Subject: Docket 50-482: Wolf Creek Nuclear Operating Corporation's
Response to Request for Additional Information Regarding 10 CFR
50.55a Requests I2R-37 and I2R-38

**Response to Request for Additional Information (RAI) Regarding 10 CFR 50.55a (Relief)
Requests I2R-37 and I2R-38**

Figure 1

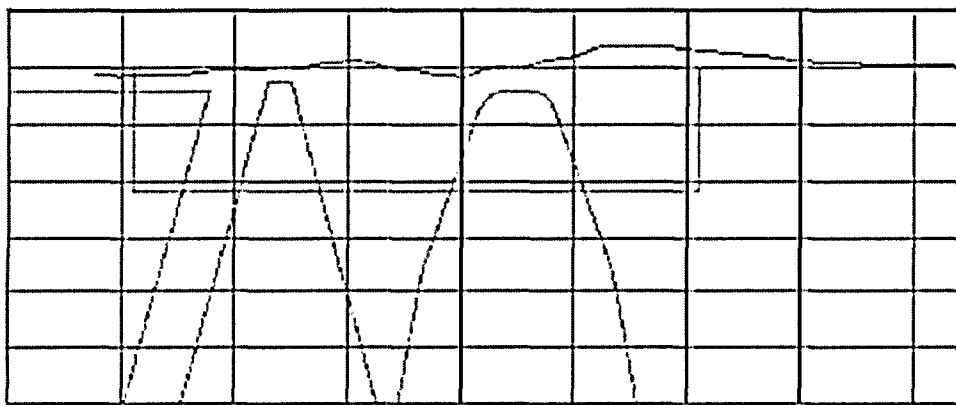
- (2) Describe the extent and locations of the observed surface irregularities and provide explanation with the assistance of sketches to show that the observed surface irregularities will only affect the detection of axial flaws. Also, discuss what measures you have taken to ensure that the surface condition of the weldment will provide a reliable eddy current examination.

The surface irregularities are located around the inside diameter of the subject welds and are the result of counterbore tapers and/or grinding of the root pass. These surface irregularities do not meet the criteria for smoothness as stated on the Performance Demonstration Qualification Summary (PDQS) for the procedure.

Examination of these welds was performed using a qualified and demonstrated procedure, PDI-ISI-254-SE. During the qualification of this procedure, the detection of axial flaws was limited due to severe irregularities in the inside diameter (ID) contact surfaces of the Performance Demonstration Initiative (PDI) test set. The detection of circumferential flaws met the Appendix VIII criteria on these surfaces with severe irregularities during the PDI performance demonstration. The attached figures 1 and 2 illustrate examples of mapped ID surface irregularities that limited the detection of axial flaws during the qualification of the vendor's procedure, but did not limit the detection of circumferential flaws.

Figure 3
Inlet piping to safe-end and safe-end to inlet nozzle welds

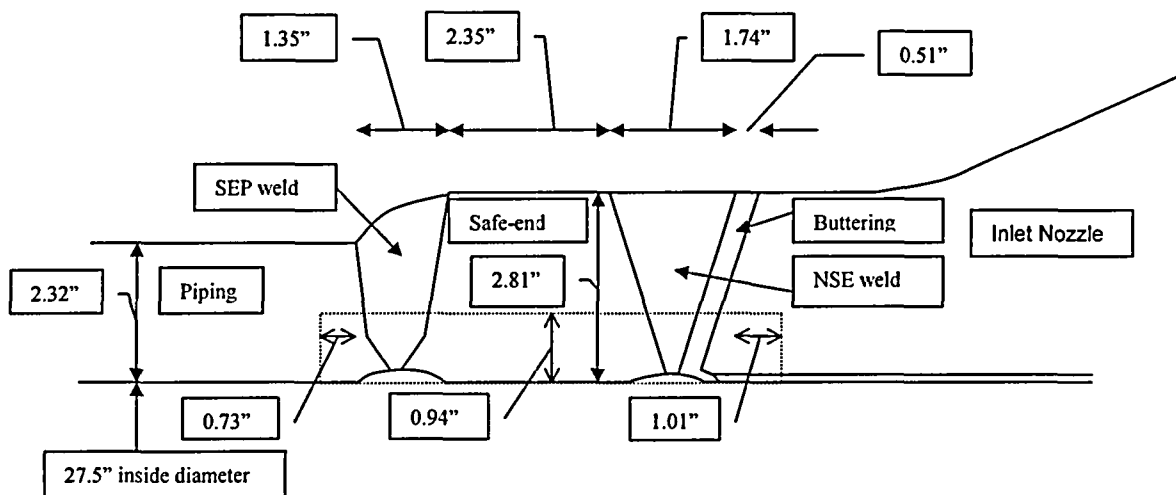
(3) For each listed safe-end component, provide the information with a sketch regarding the dimensions of the components and welds, materials, component names and the dimensions of the code required inspection volume.

See attached Figures 3 and 4 for dimensions and the table below for the component and weld material.

Per Figure IWB-2500-8(c) of ASME Section XI, the volume required to be examined is the inside surface extending up to 1/3 of the thickness of the piping and extending out to 1/4" past the edge of the weld crown on each side of the weld. The volume that was actually examined is shown by the dotted line box in the Figures 3 and 4. The figures show that the examined volume extends well beyond that required by the Code. This additional volume was added by the vendor as a "conservative scan factor".

BB-02-FW301; 6" 180 degree return (SA-312 TP304) to 6" flange (SA-312 TP304) with weld filler material of 308.

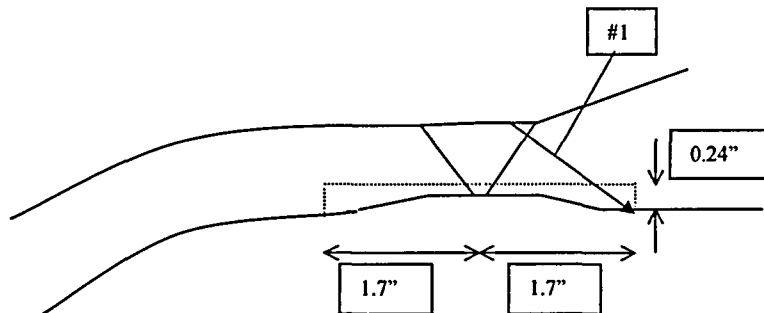
- (2) Provide the following information for each listed piping weld with the assistance of a sketch:
- materials, names and dimensions of components and welds, and
 - dimensions of the Code required area of examination coverage and the actual area of coverage based on the best effort examination.

Joint size: 6" sch. 160, nominal OD 6.625", nominal thickness 0.719"; counterbore ID 5.325"

This examination area extends to 0.25" beyond the counterbore as required.

The amount of axial coverage obtained by the best effort examination, utilizing the supplemental 60 degree longitudinal wave search unit, is 85.2% of the area on the far side of the weld. Arrow #1 in the diagram above depicts the extent of the best effort examination perpendicular to the weld. The best effort parallel scan was conducted to the extent possible from the weld crown. This scan examined 32.4% of the area on the far side of this weld.
